Access Compliance Report

Public Rights-of-Way

| Intersection ID: 30502 | Main Street: ORCHARD_GRASS_CT | Cross Street: STONES_LANDING_ST | Location: SE |
| ADA ID: A267CB9E4E36 | Ramp Type: PerpDiag | Initial Pass/Fail: Fail | Overall Compliance: No |

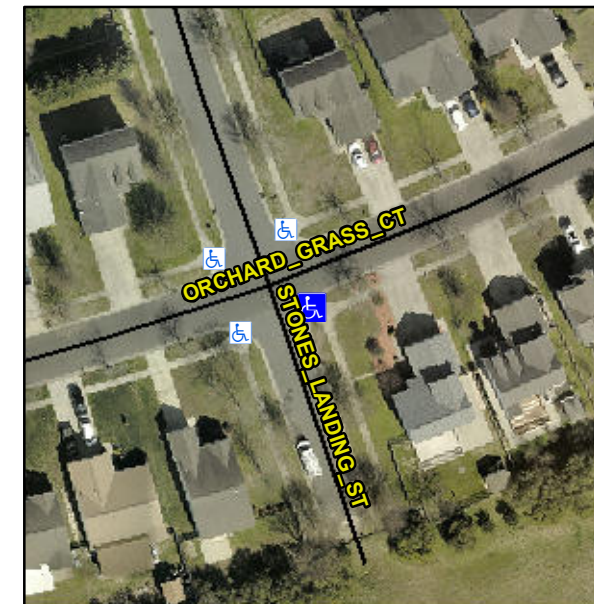
Not Found, R304.5.1

| Compliance | Description | Data | Compliance | Description | Data |
|------------|-----------------------|------|------------|-----------------------------|------|
| No | Ramp Width (in) | 38.0 | Yes | Ramp XSlope (%) | 1.4 |

Remove & Replace Curb Ramp With Two New Directional Ramps or Equivalent.
